CITY OF HANAHAN – ADDENDUM NO. 2

BID NO.: **COH#-071717**

BID TITLE: CITY OF HANAHAN FIRE DEPARTMENT #3
ROOF AND INTERIOR KITCHEN REPAIR

Yellow - Roof Repair
Red - Gutter Installation

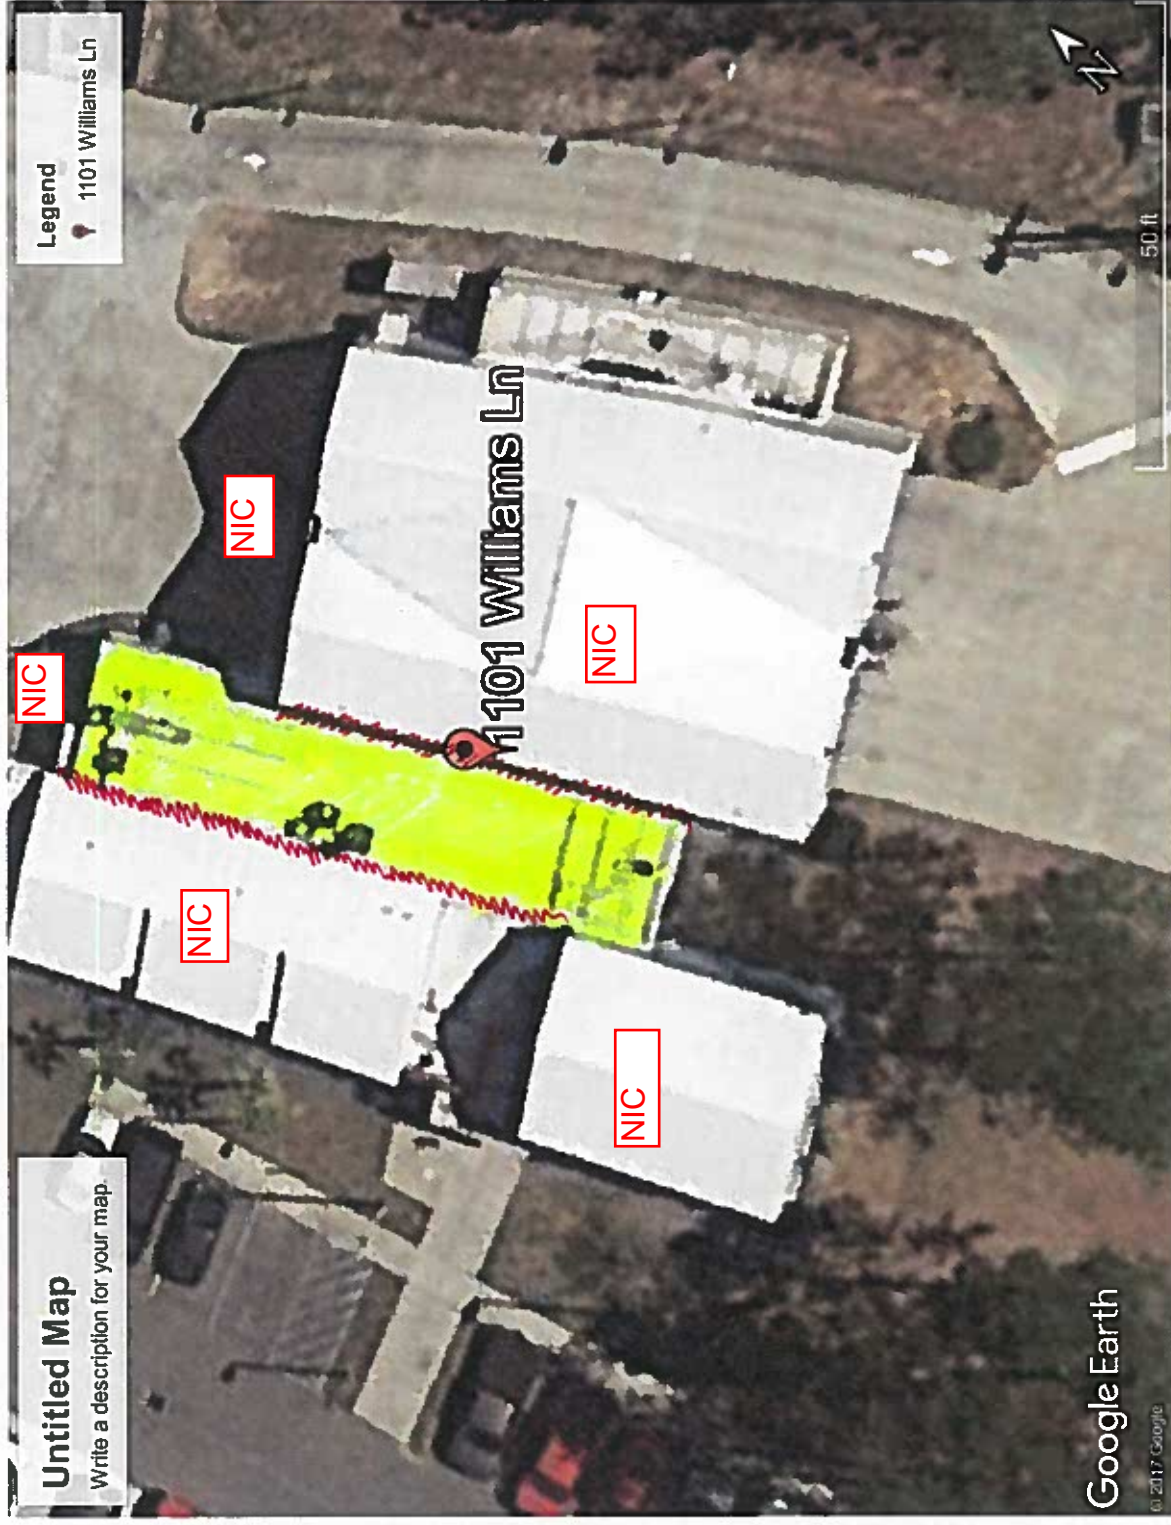
Install at least a 60mil TPO Roofing System on the **flat roof** which also extends over the kitchen area where damages incurred. These areas are highlighted in the attachment.

The area highlighted in YELLOW is the outlay of the area of roof to be repaired.

The area highlighted in RED are for gutter installation.
